**REVISED GROUNDWATER CONTAMINATION  
PLUME REMOVAL ACTION ENGINEERING  
EVALUATION/COST ANALYSIS (EE/CA)  
ADDENDUM**

**DOE-291-92  
DOE-FO/EPA  
2  
LETTER**

## ADDENDUM TO SOUTH GROUNDWATER CONTAMINATION PLUME REMOVAL ACTION EE/CA

FIGURE 1  
New location of Recovery  
Well Field

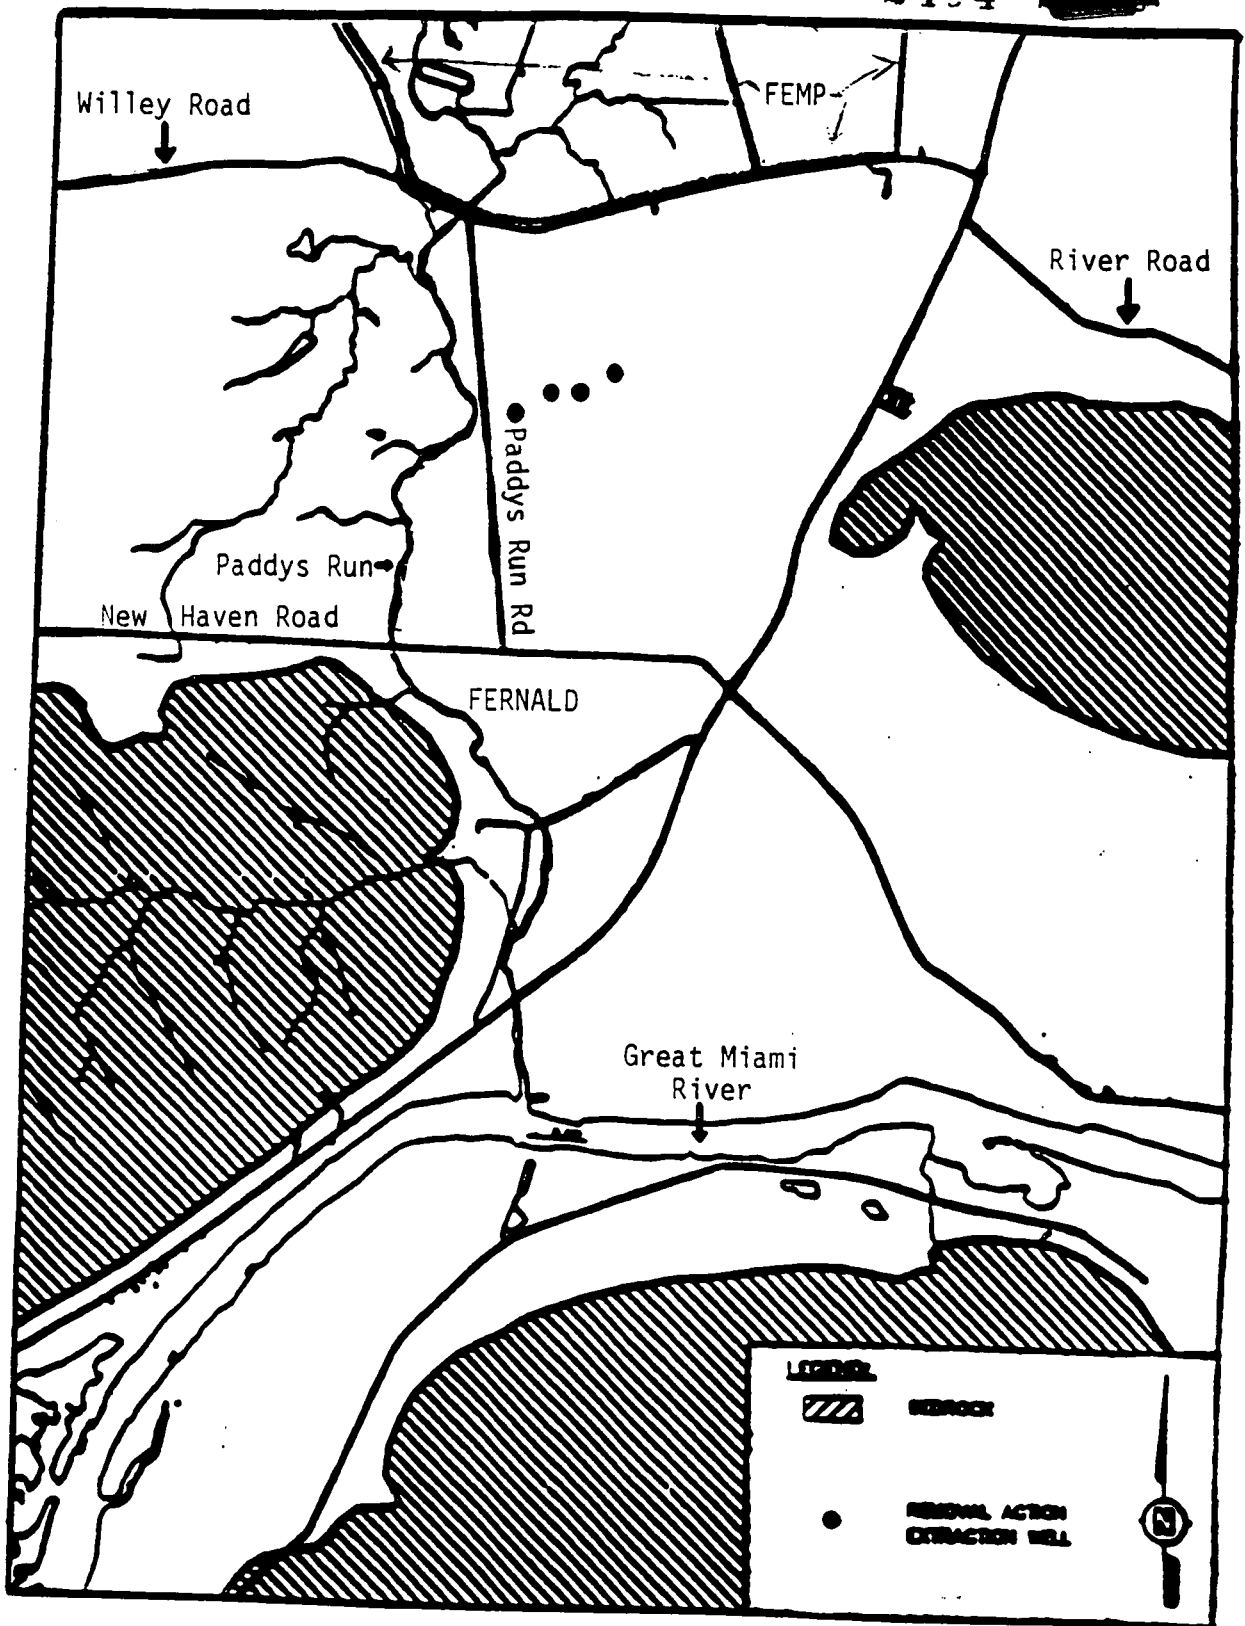
As a result of these conditions, it has been deemed necessary to relocate the Part 2 well field to an area north of the PRRS. Modeling efforts have been performed to determine a location where pumping of the recovery well field will not significantly affect the PRRS plume and will not draw PRRS contaminants into the recovery well field. Figure 1 depicts the new location of the South Plume Removal Action Part 2 well field.

Page 4-5: Paragraph 4, 1st Sentence reads: Three to five recovery wells are tentatively planned for installation just south of New Haven Road to intercept the plume.

Paragraph 4, 1st Sentence is modified to read: Three to five recovery wells are tentatively planned for installation north of the Albright & Wilson Americas (AWA) Plant. The recovery wells are shown conceptually in Figure 1 of this Addendum.
